# Access Compliance Report

## Public Rights-of-Way

Intersection ID: 10017494	Main Street: MILHAVEN_LN	Cross Street: N/A	Location: SW
ADA ID: D29F37E9BB72	Ramp Type: Perp	Initial Pass/Fail: Fail	Overall Compliance: No
Severity Score: 25			
Codes/Mitigation Info/Possible Solution		Field Measurements/Component Compliance

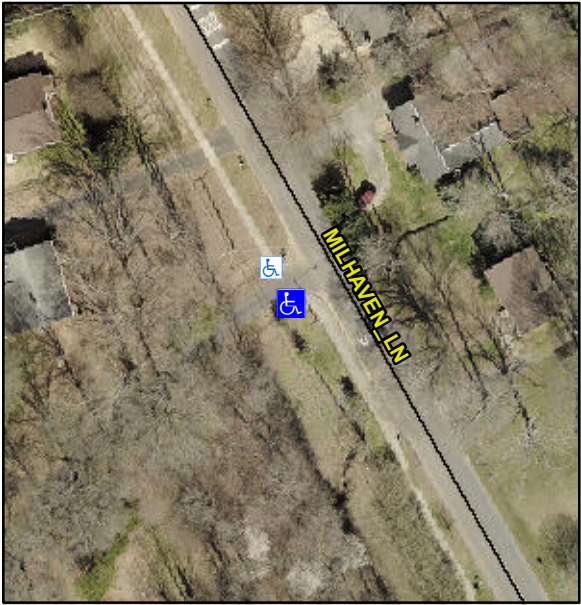
Possible Solutions:	Compliance	Description	Data	Compliance	Description	Data
	Remove & Replace Entire Ramp.	N/A	Ramp Length (in)	31.0	No	Ramp Slope (%)	8.8
		Yes	Ramp Width (in)	62.5	No	Ramp XSlope (%)	5.9
		N/A	Flare Type LT	N/A	N/A	Flare Type RT	N/A
		N/A	Flare Slope LT (%)	N/A	N/A	Flare Slope RT (%)	N/A
		N/A	Flare Traversable LT?	N/A	N/A	Flare Traversable RT?	N/A
		N/A	Landing Length (in)	N/A	N/A	DWS Provided?	N/A
		N/A	Landing Width (in)	N/A	N/A	DWS Contrast?	N/A
		N/A	Landing Slope (%)	N/A	N/A	DWS Length (in)	N/A
		N/A	Landing X Slope (%)	N/A	N/A	DWS Full Width?	N/A
		N/A	Landing Curb? (Y/N)	N/A	N/A	DWS Offset (in)	N/A
		N/A	Shared Landing?	N/A			
		N/A	Gutter Ponding?	N/A	N/A	Gutter Slope (%)	N/A
		N/A	Gutter Lip Ht (in)	N/A	N/A	Gutter X Slope (%)	N/A
		N/A	Painted X Walk1?	No	N/A	Painted X Walk2?	N/A
			X Walk 1 Direction	To N		X Walk 2 Direction	N/A
		N/A	X Walk 1 Width (in)	N/A	N/A	X Walk 2 Width (in)	N/A

X Walk 1 Slope (%)	5.0		X Walk 2 Slope (%)	N/A
			X Walk 1 X Slope (%)	5.6		X Walk 2 X Slope (%)	N/A
		N/A	Ramp inside XWalk1?	N/A	N/A	Ramp inside XWalk2?	N/A
<p>Surveyor Notes:</p> <p>N/A</p> <p>PROW/ADA:</p> <p>Not Found, R304.2.2, R304.5.3</p>			Road Slope (%)	N/A	N/A	Clear Space?	N/A
			Road X Slope (%)	N/A	N/A	Clear Space to XWalk (in)	N/A
		N/A	Any Obstructions?	N/A	N/A	Storm Grate/Utility Hazard?	N/A
			Obstruction Type			Storm Grate/Utility Type	
					N/A		N/A
					Yes	Surface Condition? (G/P)	Good
